21 SUB2012-00129

GULF CREEK SUBDIVISION, RESUBDIVISION OF LOT 15

DETAIL SITE PLAN

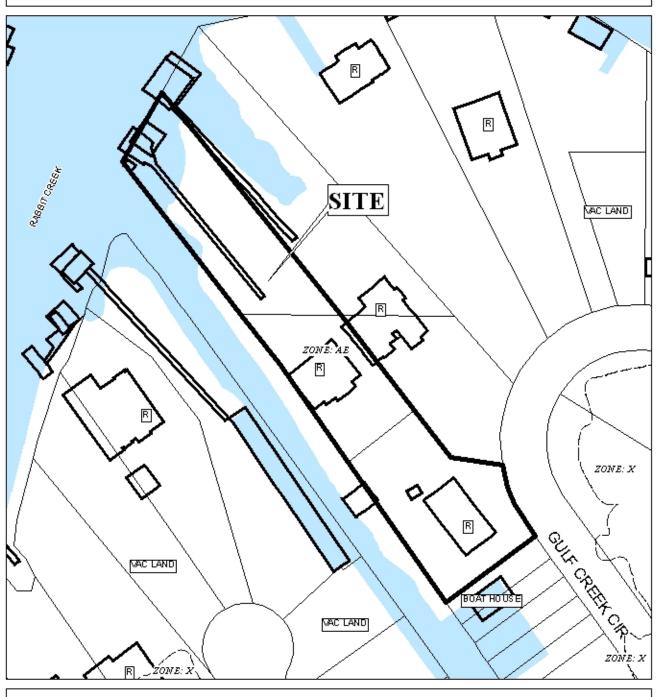
The site is located on Gulf Creek Circle which is a minor street without curb and gutter. As a minor street, there should be a 60' right-of-way. The plat depicts the right-of-way for Gulf Creek Circle as 50' this should be revised to illustrate dedications to provide 30' from the centerline of Gulf Creek Circle.

The proposed Lot B does not meet the standards for width-to-depth ratio. Section V.D.3. of the Subdivision Regulations states that lot depth should not exceed 3.5 times the width of the lot at the building setback. It appears that there are several parcels in the area that are similar in shape and size that are legal lots of record, therefore waiver of Section V.D.3. of the Subdivision Regulations would be appropriate.

A 25' minimum building setback line is indicated on the preliminary plat and should also be illustrated on the Final Plat.

Based upon the preceding, the application is recommended for tentative approval, with a waiver of Section V.D.3. of the Subdivision Regulations, subject to the following conditions:

- 1) retention of lot area size in square feet, on the Final Plat;
- 2) placement of a note on the Final Plat stating that each lot is limited to the existing curb- cuts to Gulf Creek Circle with the size, design, and exact location of all curb cuts to be approved by Traffic Engineering and conform to AASHTO standards;

- 5) Retention of a 25' minimum set back line after dedication and;
- 6) Placement of a note on the Final Plat stating that any lots which are developed commercially and adjoin residentially developed property must provide a buffer, in compliance with Section V.A.8. of the Subdivision Regulations.
